10-E-21-HZ
APPLICATION FOR CERTIFICATE OF APPROPRIATENESS

120 Leonard Place 37917
Old North Knoxville H

Original Print Date: 10/8/2021
 Knoxville/Knox County Planning -- Historic Zoning Commission

Description of Work

Back Deck
 12 x 20

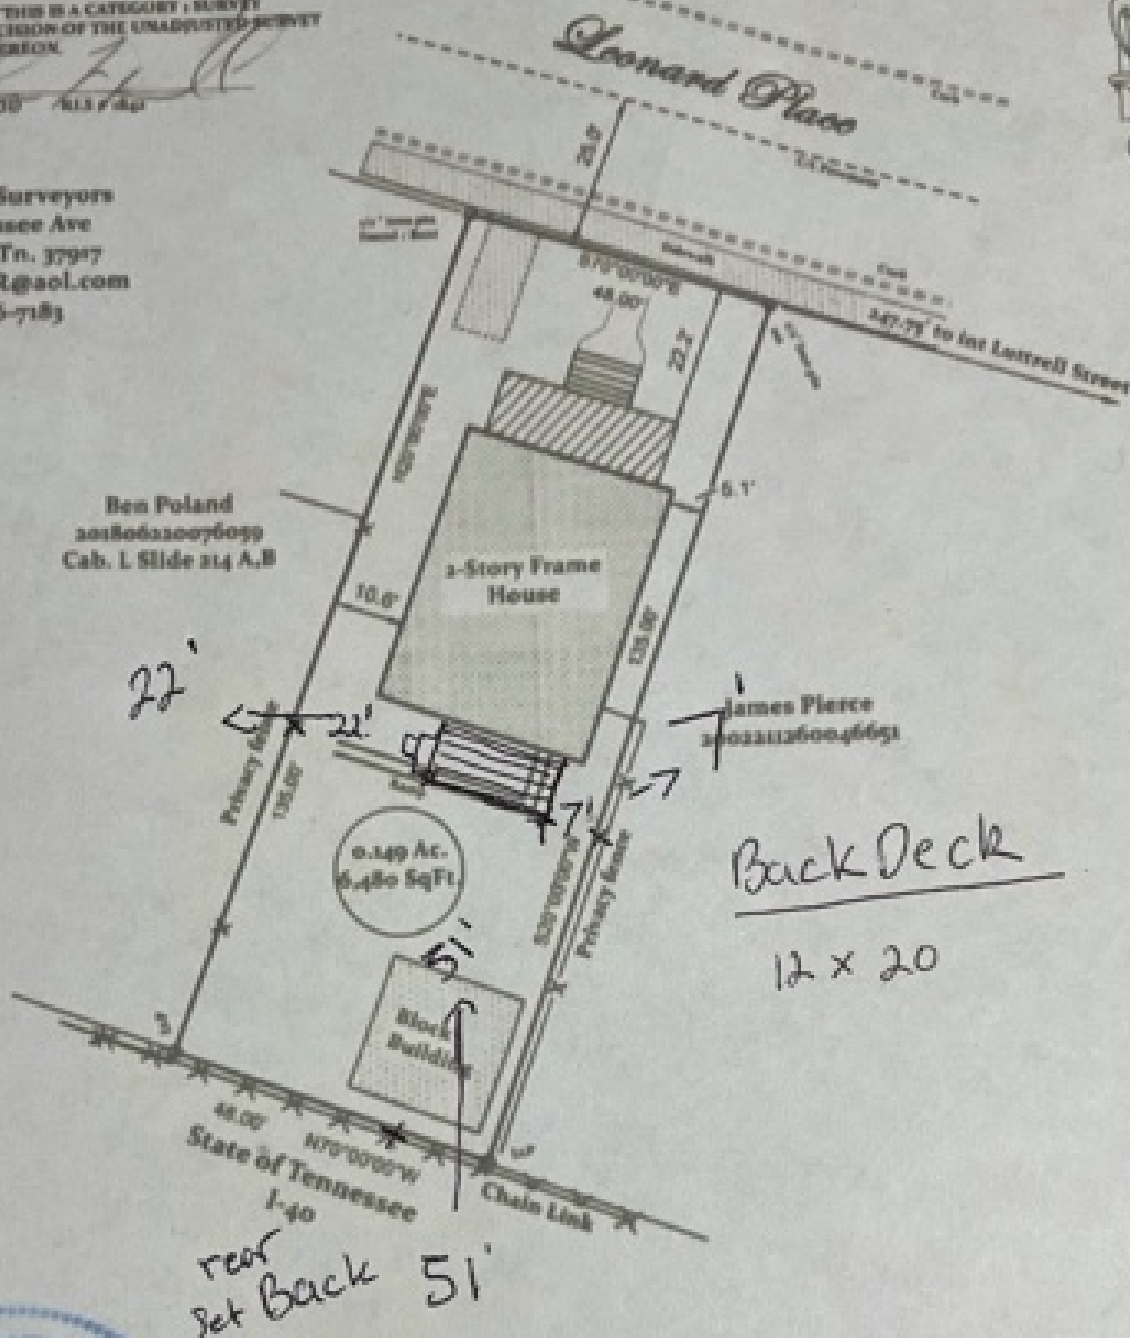
1. The rear deck is minor in size, replacing a non-historic wood access ramp, and will not be visible from the street. The deck meets the setback requirements of the base zoning code. Placement of the deck is appropriate.

2. A pressure-treated wood rear deck is supported by the design guidelines. The applicant should submit a drawing showing the balustrade and rail's size and design; balusters should be set into the top and bottom rail.

- 1) dimensions and design of deck balustrade to be submitted to staff for review, with balusters set into the top and bottom rails;
- 2) final specifications of replacement columns to be provided to staff, with columns to match existing in diameter, height, and design.
